1984 Corvette: Service Bulletin: Broken Window Regulator Tapes

Source: Chevrolet Dealer Service Bulletin

Bulletin No: 84-3

Date: Oct., 1983

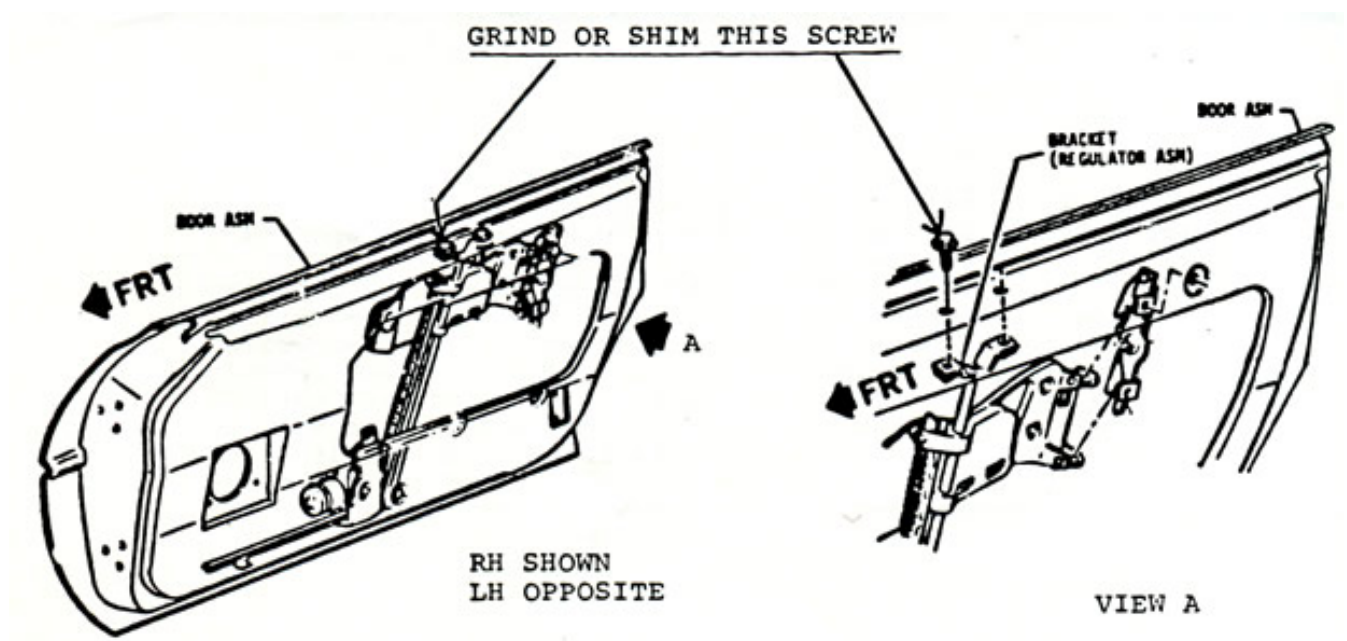
Whenever a vehicle requires service of door components, inspect for interference between the forward upper attaching screw and the upper end of the tape drive. If interference exists, one of the following options should be performed:

1. Add a washer (P/N 14038397), or equivalent, under the upper forward attaching screw (See Illustration).
2. Remove the forward attaching screw (P/N 11503800) and grind approximately 3mm from the threaded end.

This is to prevent contact between the bottom of the screw and the upper end of the tape drive. If this contact exists, excessive stress is created in the tape and could cause a failure.
